STAFF REPORT: 12/16/2020 MEETING

APPLICATION NUMBER: #20-6988

ADDRESS: 701 W. CANFIELD

SCOPE: REPLACE EXISTING VINYL AND WOOD WINDOWS WITH ALUMINUM CLAD WOOD WINDOWS

H.22 | 3/8" = 1'-0"

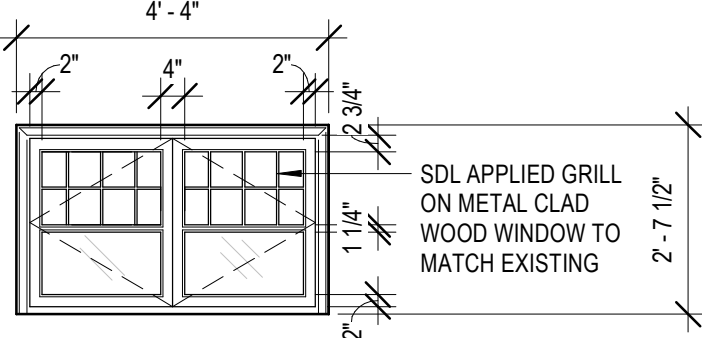
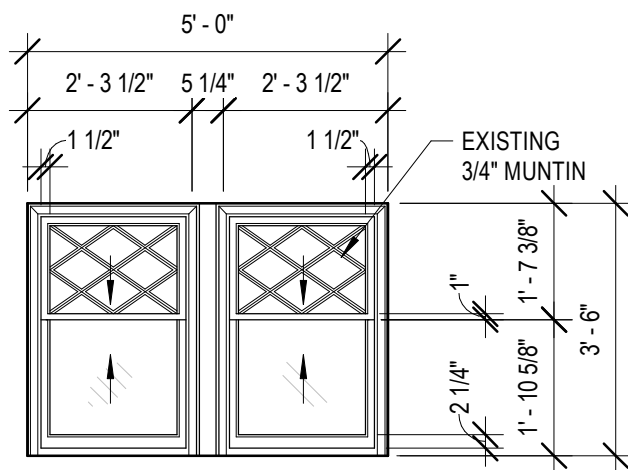
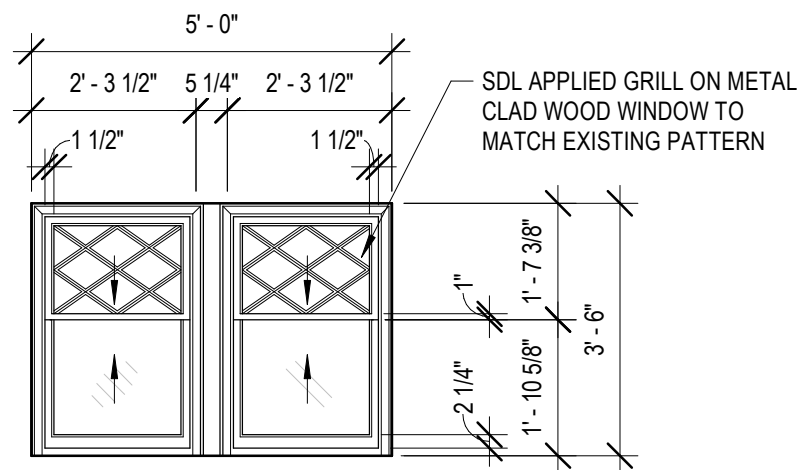
- Details of the existing muntin grids of the front elevation upper floor windows appear to match the proposed windows with applied grill on metal clad wood windows (See Sheet H22).

1 EXISTING WINDOW DETAIL - DH WITH TRANSOM

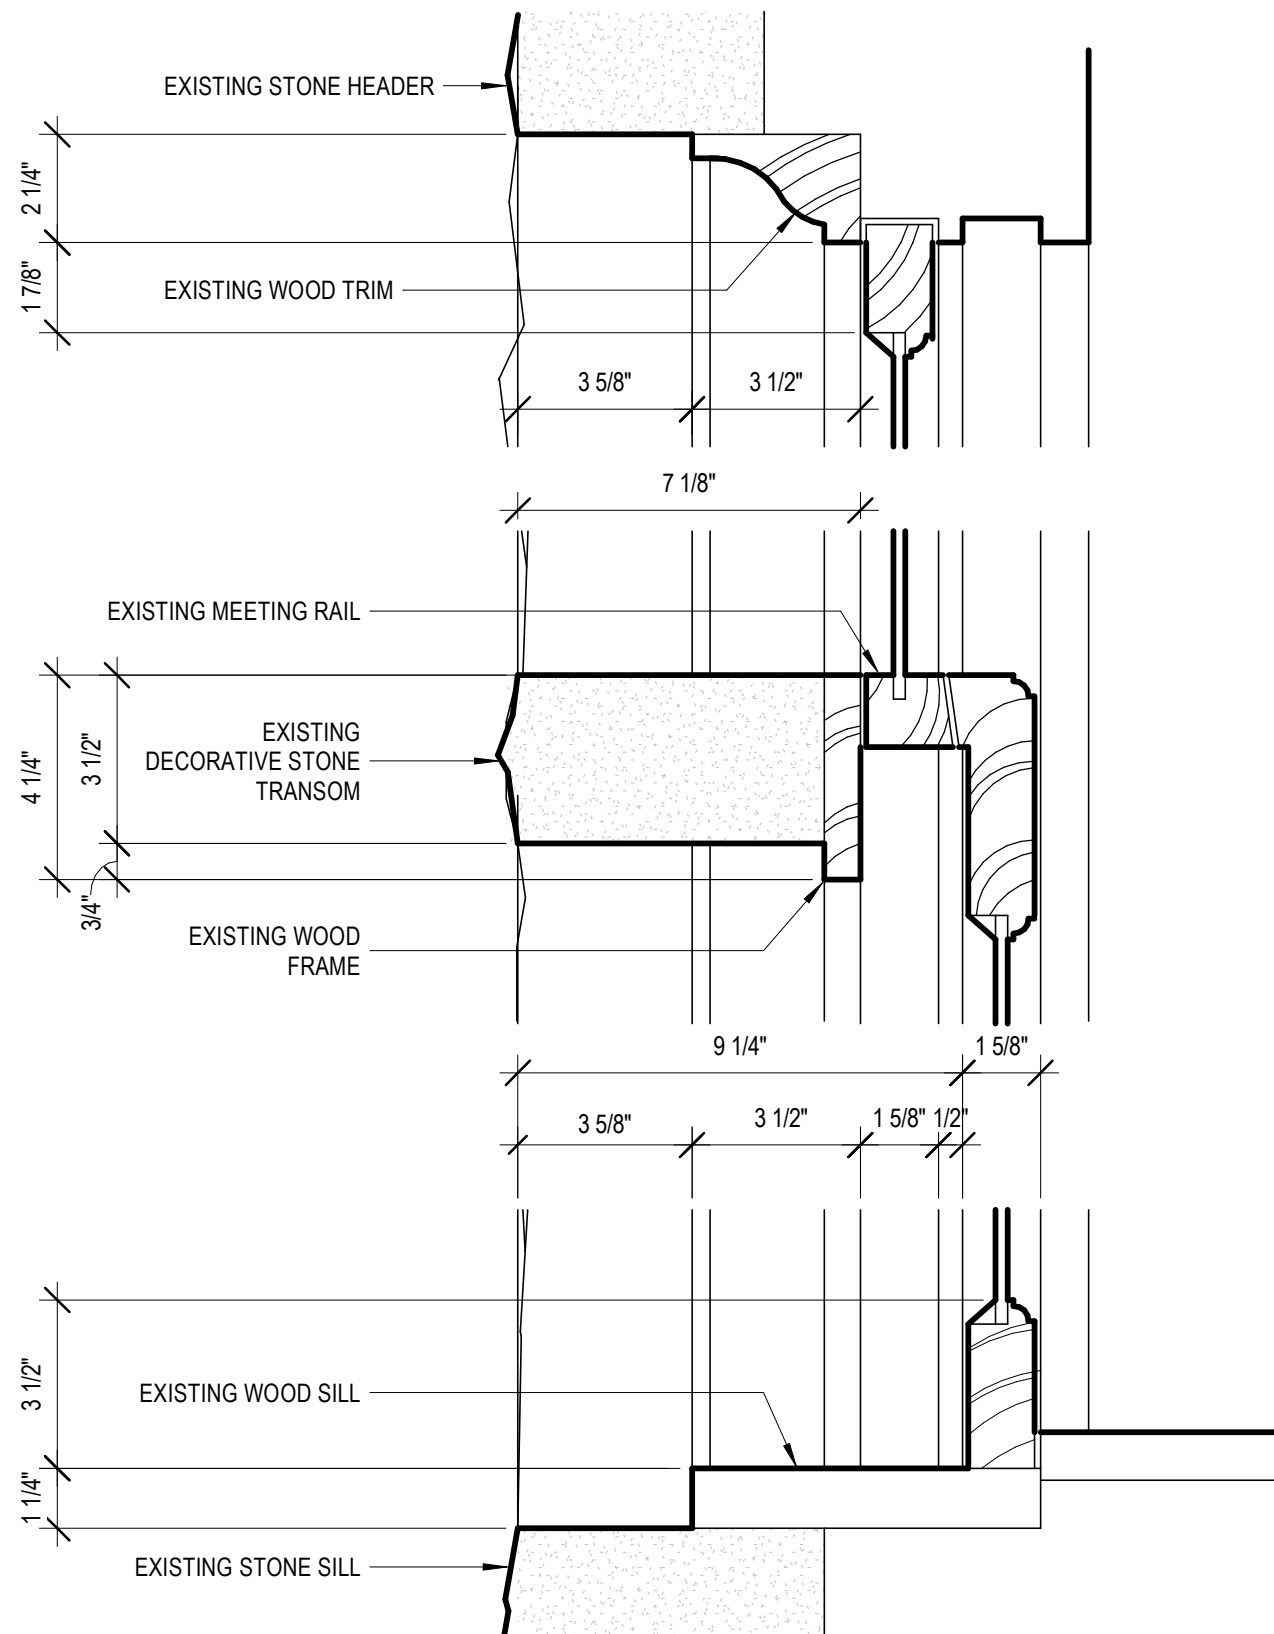
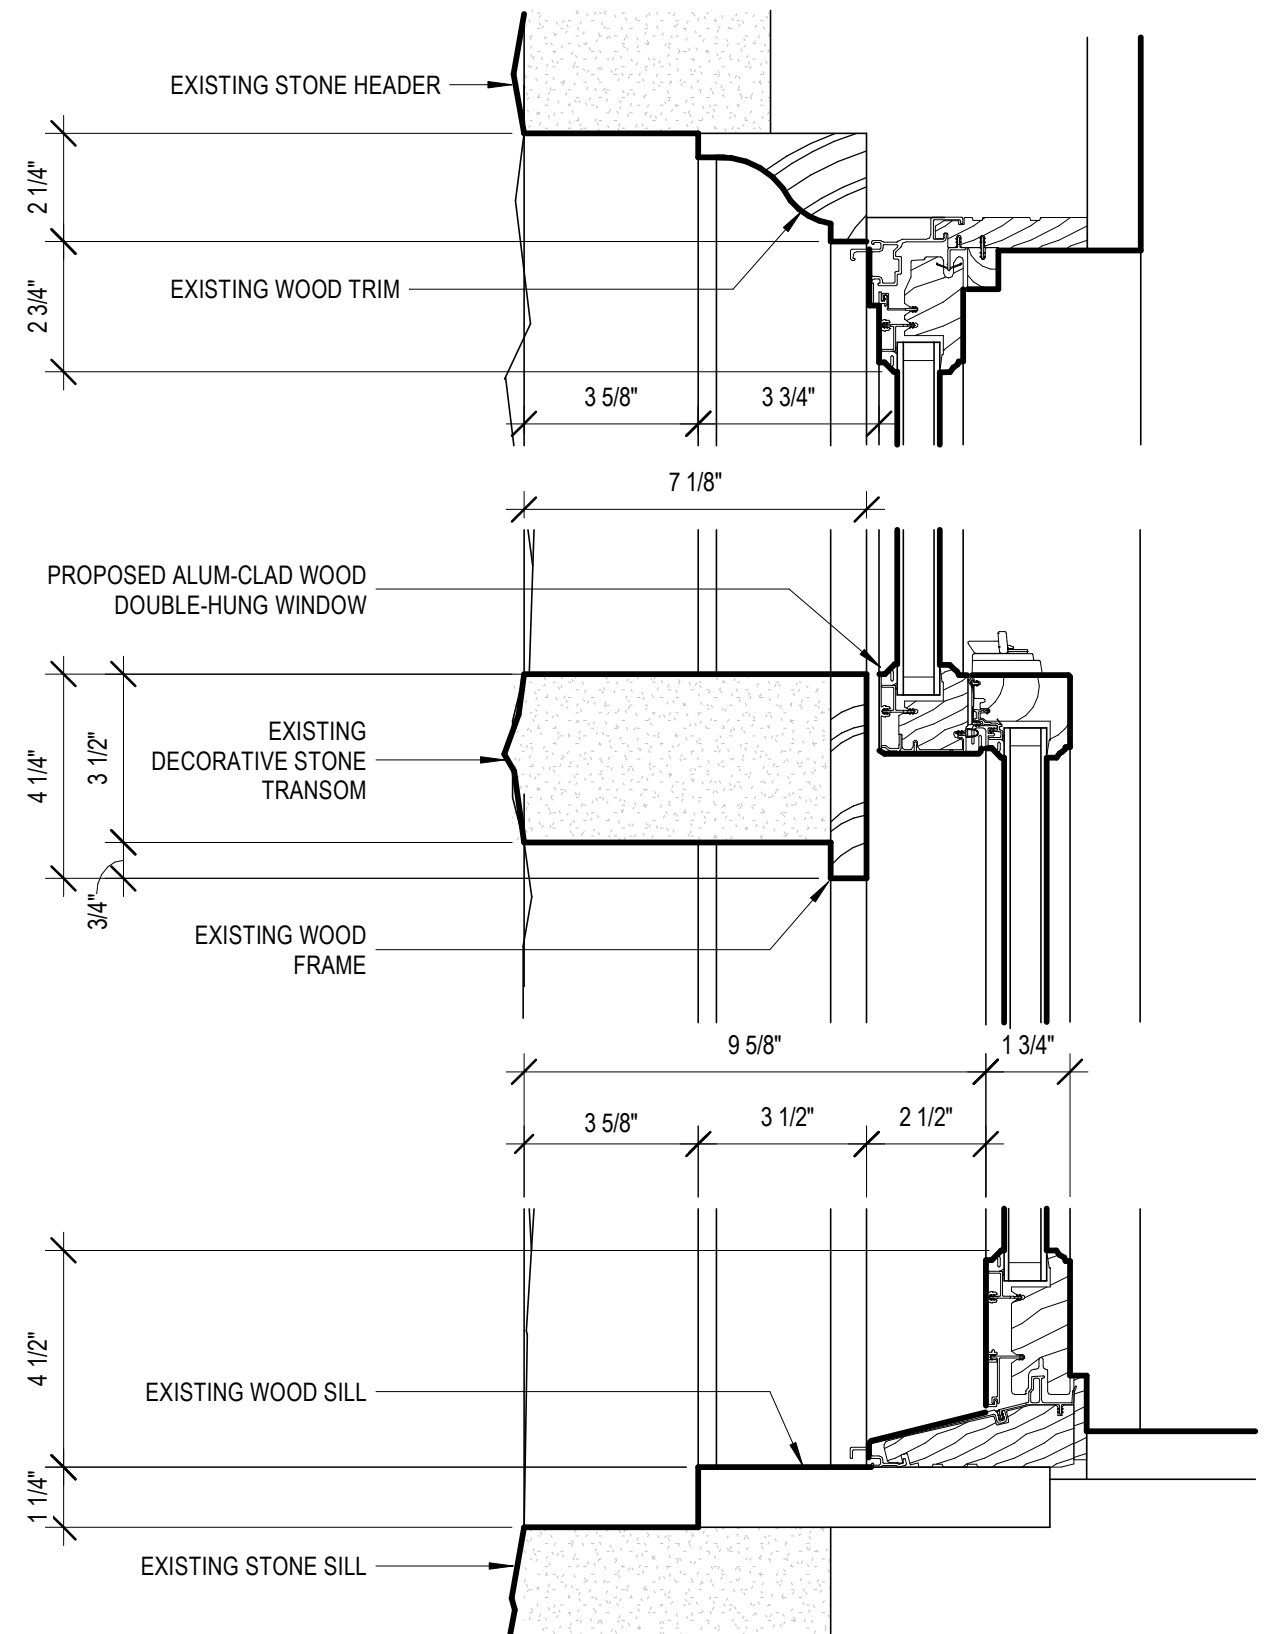
- The brick mold shown in the cross sections (See Sheets H25) are labeled in the drawings as “existing wood trim”, and are proposed to be retained.
- Although replacement of wood windows does remove and alter distinctive features or finishes of the property, aluminum-clad windows are a reasonable and economically feasible product for the replacement of wood windows that are demonstrably beyond repair.

- The brick mold identified in the drawings be retained. If areas of the brick mold have deteriorated beyond repair, the applicant may replace with in-kind material, per staff review of replacement confirming match in material, profile, and dimension
- The wood mullions at the windows are retained
